Reply letter manuscript “Uncertainties in Coastal Flood Risk Assessments in Small Island Developing States”

Reviewer #1

Reviewer #2

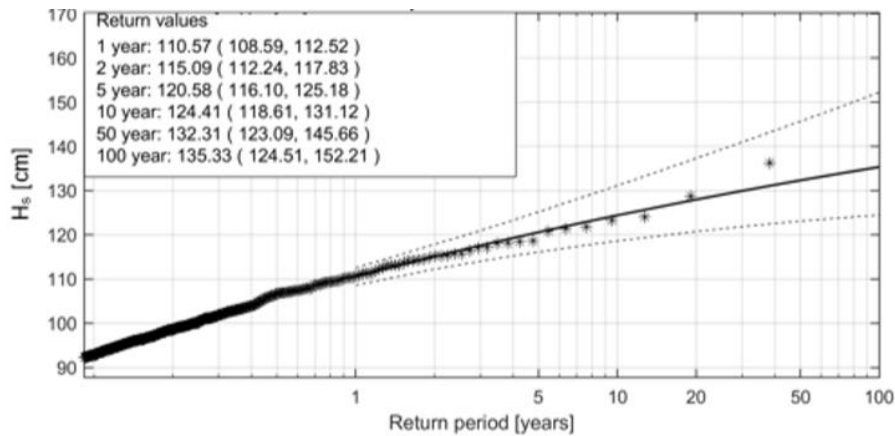
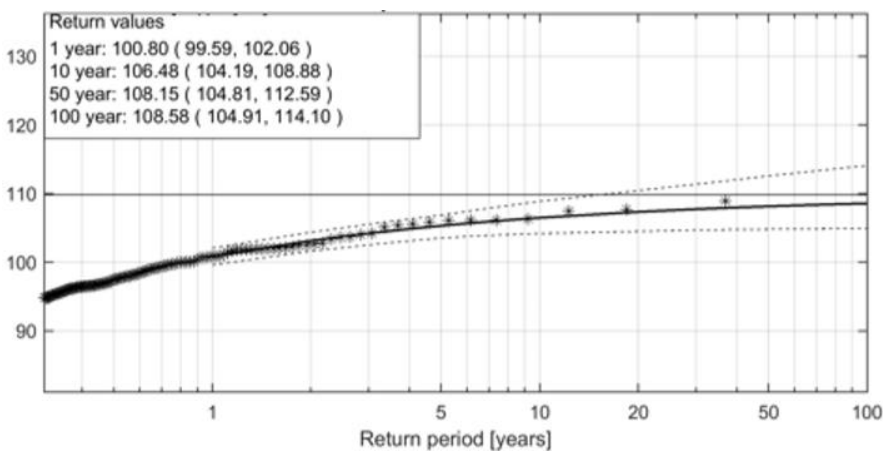
1) Page4, line20, the authors straight away analysed a 100-year return period for the analyzed region. Although for most of the developed nations, flood protection standard assumes 100-year as the benchmark, however, for pristine locality like the two analyzed here, directly moving to a 100-year return level may lead to erroneous results based on a limited number of records available.

Further, the study uses data from different sources, such as GTSR data, which is based on a 35-year record, which may not be equivalent to the length of other available records used in the analysis. Hence, data from different sources with varying record lengths would impart additional uncertainty in the analysis. Although the return period could approximate the hazard potential beyond the record length, however, in this case, the uncertainty bound would be larger with longer return period estimates. Hence, it would be interesting to know the hazard potential on smaller return levels such as 10-year or 25-year first, that covers the analysis period before moving to the larger one.

We thank the reviewer for the very good comment. We analysed different return periods and found that, for the considered locations, smaller return periods had a very little difference in the range of values between the 5th and 95th percentile values (13 cm spread for the 10-year return value and 28 cm spread for the 100-year return value for offshore significant wave height; 5 cm spread for the 10-year return value and 8 cm spread for the 100-year return value for storm surge level). The estimated values for different return periods for the two variables (i.e. significant wave height and storm surge levels) are shown in Fig. 1 and Fig. 2 which have been added for completeness to the rebuttal letter. In the top left of the figure, the 50th percentile, together with the 5th and 95th percentile values in brackets, are shown for each return period.

Furthermore, the 50th percentile value did not increase significantly from a 1-year return value to a 100-year return value for both investigated variables (1.10 m to 1.35 m for offshore significant wave height; 1 m to 1.08 m for storm surge level). Therefore, the hazard potential on smaller return periods (e.g. 10-year or 25-year) would have not differed significantly from the one computed using the 100-year return period. Moreover, the 5th to 95th percentile values range for the 100-year return period, which was analysed as part of this paper, included the 50th percentile value for the 10-year return period.

The choice of the 100-year return period, instead of the use of other return periods, was arbitrary and with the only objective to investigate uncertainty. This has been clarified in the manuscript: “In this analysis, arbitrarily chosen 100-year return period extreme sea levels event were modeled since, for this case,

events with smaller return periods had only a small difference in intensity and computed flood damages than the 100-year return period event.”, see page 4, line 25.

We agree that using data with varying record lengths would impart additional uncertainty on the analysis and the issue has been mentioned: “Separate datasets with different recorded lengths were used for the statistical estimation of the storm surge level and significant wave height 100-year return period values, which is an additional source of uncertainty in the damage prediction”, see page 12, line 16.
